# UNITED STATES PATENT AND TRADEMARK OFFICE

APPLICATION NO.	FILING DATE	FIRST NAMED INVENTOR	ATTORNEY DOCKET NO.	CONFIRMATION NO.
10/813,069	03/31/2004	Rudolf Moller	32368-199846	5288

## Office Action Summary

## **DETAILED ACTION**

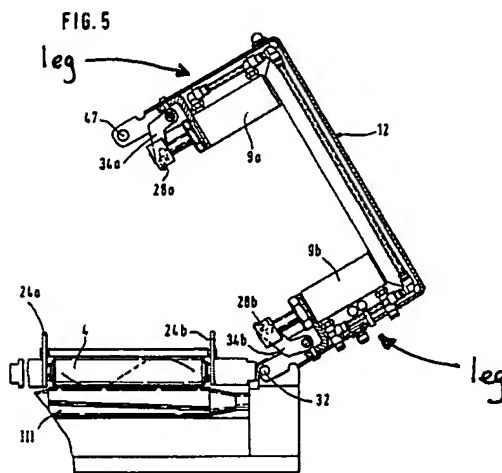
Roder discloses a double pressure cylinder arrangement having a first pressure cylinder 9a, a second pressure cylinder 9b positioned in a spaced and axis-parallel relationship to the first pressure cylinder 9a, a carrier strut 12 having a hollow intermediate section (see figure below) connected to the bottom side of the first pressure cylinder 9a and the second pressure cylinder 9b, a substantially u-shaped housing element (see figure below) having two leg sections wherein each leg section houses one of the pressure cylinders (9a, 9b) and connection lines (see figure below) for driving the first pressure cylinder 9a and the second pressure cylinder 9b integrated in the intermediate section.

With regard to claim 5, a fluid connection supplies fluid to the first pressure cylinder 9a and to the second pressure cylinder (see figure above; Col. 6, lines 61-65).
